NOTICE UNDER SCHEDULE VI CHAPTER XI, RULE 2 (I) OF
THE CITY OF KARACHI MUNICIPAL ACT 1933.Karachi 26.2. 1935.

Case No. P/Q 159/35.

Re; Plot No:35. Sheet A.M.2. Artillery Maidan

PLAN OF PROPOSED BUILDING ON
PLOT No 35 SHEET A.M. 2 ARTILLERY MAIDAN

PLAN OF PROPOSED BUILDING ON
PLOT No 35, A.M.2 ARTILLERY MAIDAN
SCALE 8:1

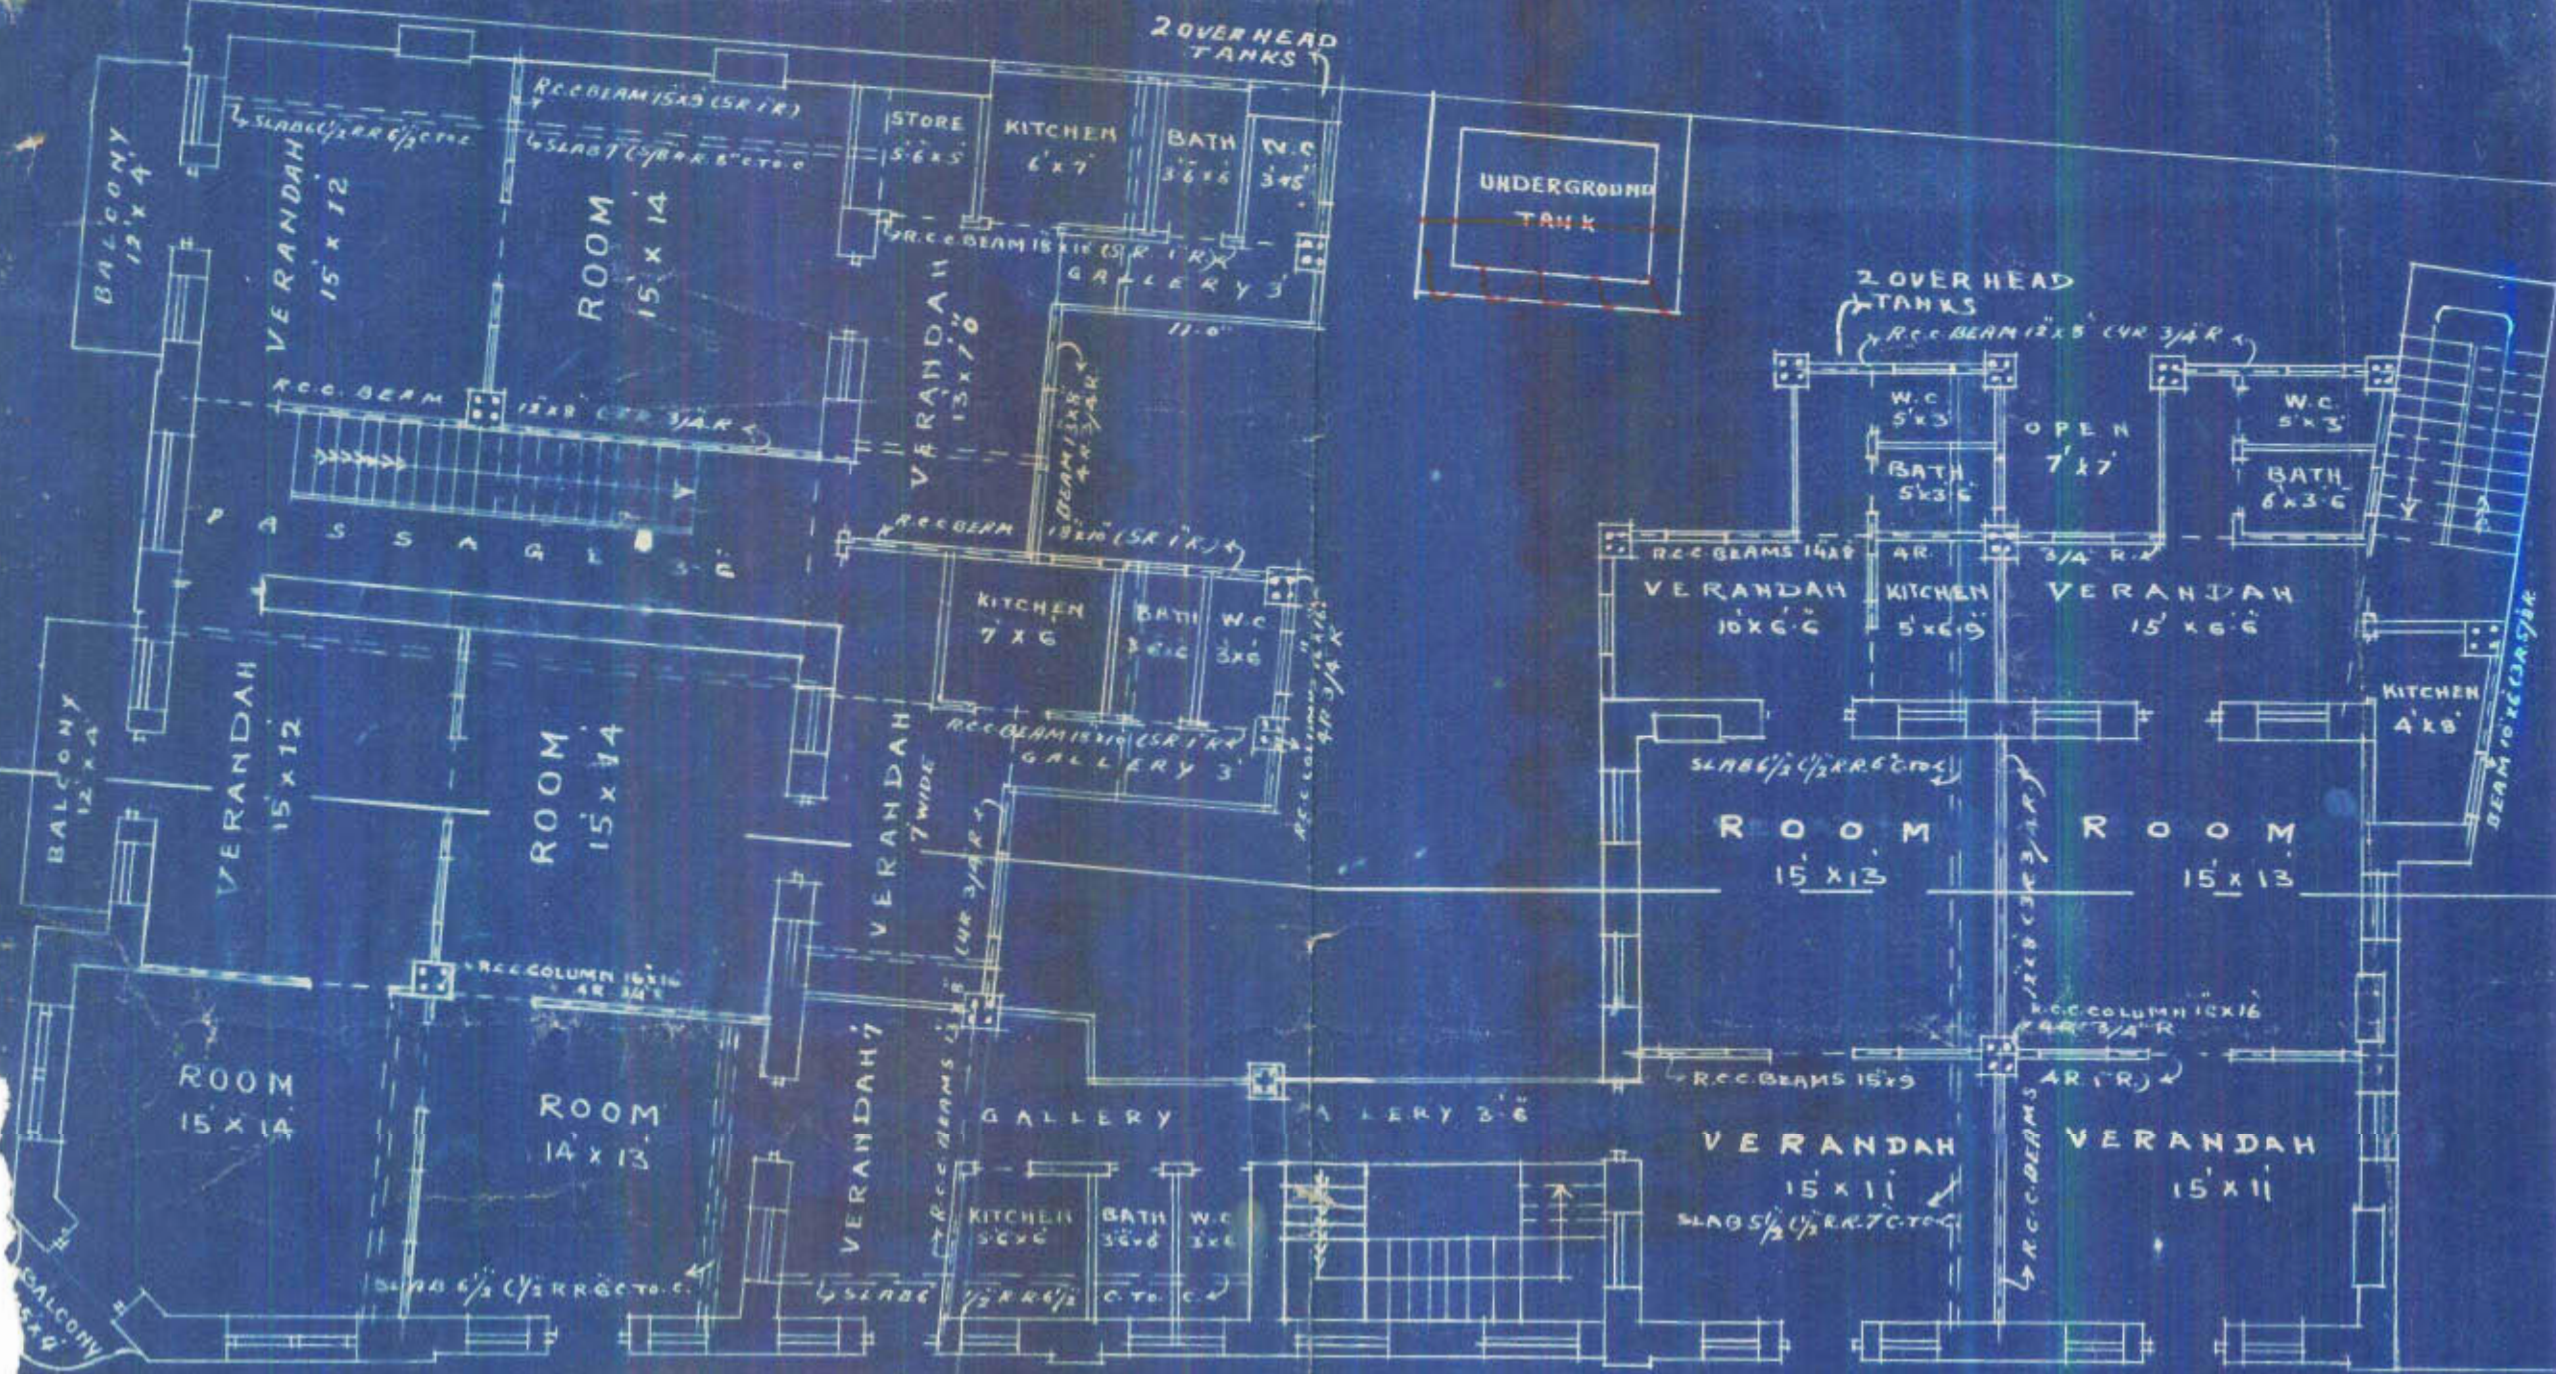
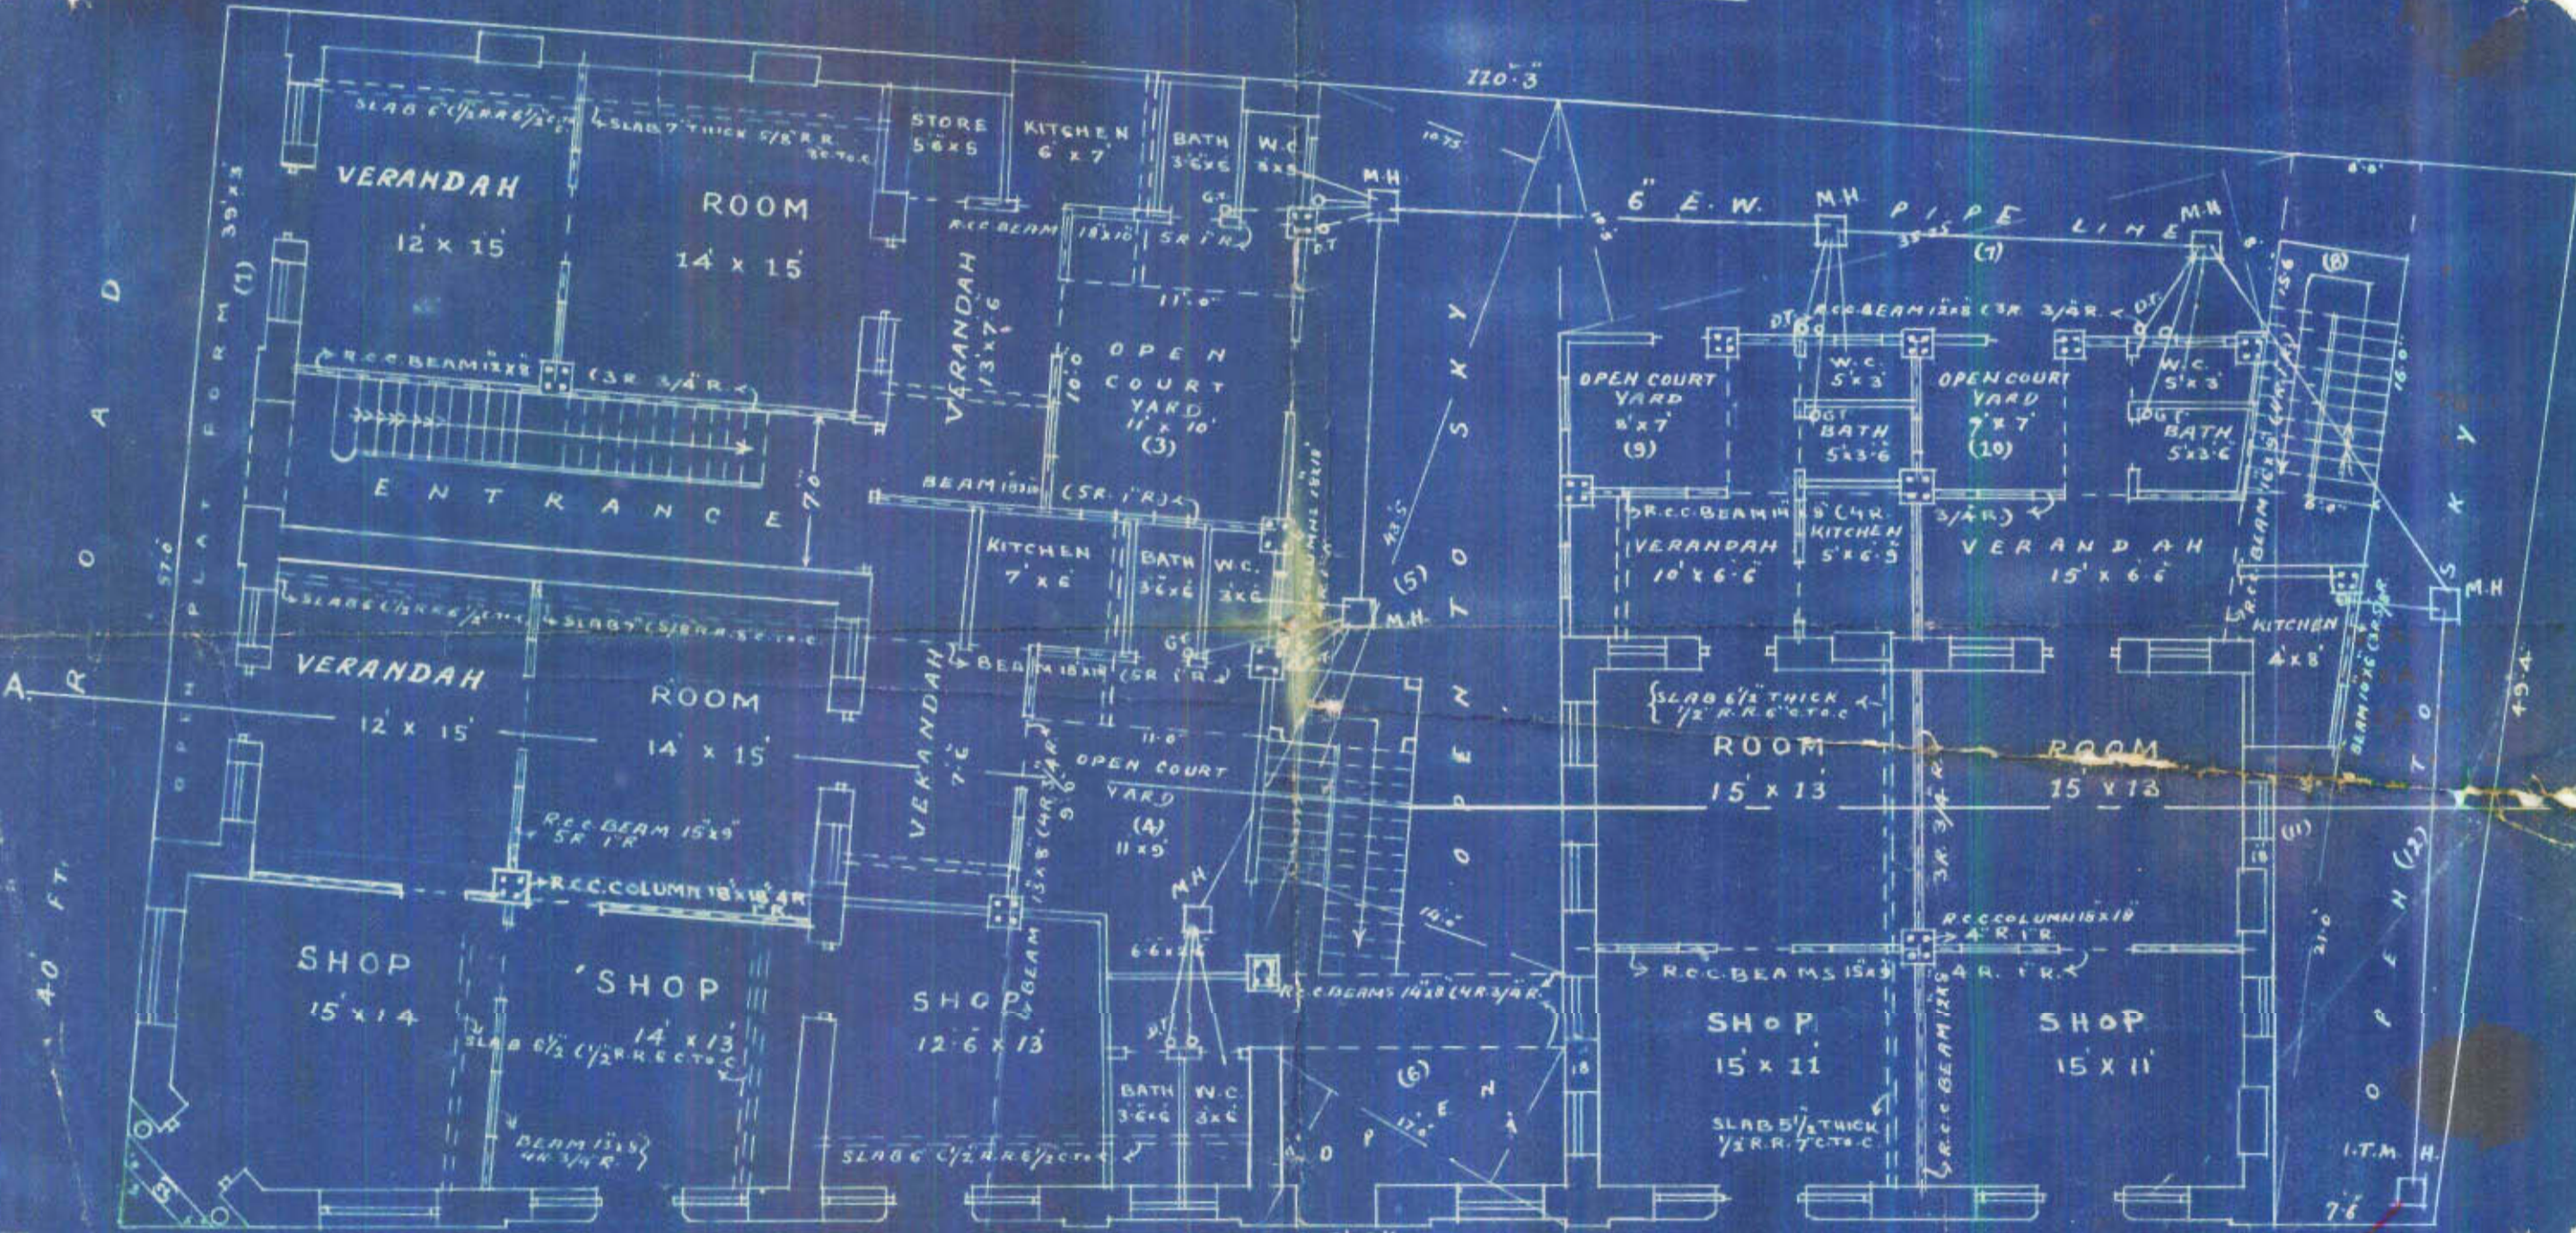
1. Rooms marked in red pencil are not sufficiently ventilated. Premises will not be permitted to occupy unless they are connected with drainage system.

2. Drainage lines should be shown on the plan.
3. Position of underground and overhead tanks and arrangement of access to the latter should be shown on the plan.

4. The external dimensions of the structures proposed to be built must be given and the built up area calculated accordingly. The open space as taken into calculation of open area are as per scale which will lead to mistakes when the building is erected.

5. Balcony at the south west corner must be dimensioned.
6. Staircase marked "A" will be taken in built up area.
7. For a wall exceeding 30ft in length and having its length between 35' to 45', the thickness must be ~~23"~~ 18", 18", 18". Even if a cross wall is provided the thickness must be 18", 18" and 14" for the same.

8. Atleast 14ft open space in width is required for the rooms that do not abut the street for the proposed height of the building.
9. A live plan is returned herewith rejected. The plans are returned herewith rejected. A street direct or shall have open verandah. In the proposed building the verandah are proposed to be closed which cannot be allowed. Yours faithfully

1. The built up area arrived at by taking the dimensions of the various structures into consideration exceeds the allowable area.
2. Objections Nos: 6, 8, 9 & 10 still require to be complied with.
3. The Architect is requested to come and see the Building Surveyor so that the built up area calculations be jointly worked out and the plans disposed of further.

- (1). Objection I has been personally discussed and complied with the Health Officer.
- (2). Drainage lines have been shown.
- (3). Under ground and overhead tanks have been shown. Access to them will be provided.
- (4). External dimensions of Building have been given.
- (5). Balcony at south end corner has been dimensioned.
- (6). The staircase pointed out is open to the sky entirely, and has no covering. You may therefore kindly waive this requirement of yours.
- (7). Cross walls have been provided, where required and the required thickness of wall has been provided.
- (8). Rooms that do not abut on the street, abut on verandahs which abut on streets or open spaces.
- (9). The back verandahs are ~~provided~~ proposed to be covered from view by a partition 7' in height and not closed entirely. This has been made clear in the plan.
- (10). The plans have been corrected.

- (1 & 3). These requirments have been personally discussed
and satisfied with the Building Surveyor. The area
has been corrected.
- (2). Staircase as pointed out in objection No: 6. of your
previous letter has been shifted and no longer comes
between two walls, and as such can not be counted in
built up area. Objections 8, 9, and 10 have already
been complied with and the Building Surveyor persona
lly satisfied. Partitions between rooms and verandahs
have been taken upto a height of 8' only where
required.

The back verandahs have been partly covered with
cement block partitions and partly with trellis
work as personally ~~xxxxxx~~ arranged with the
Building surveyor.
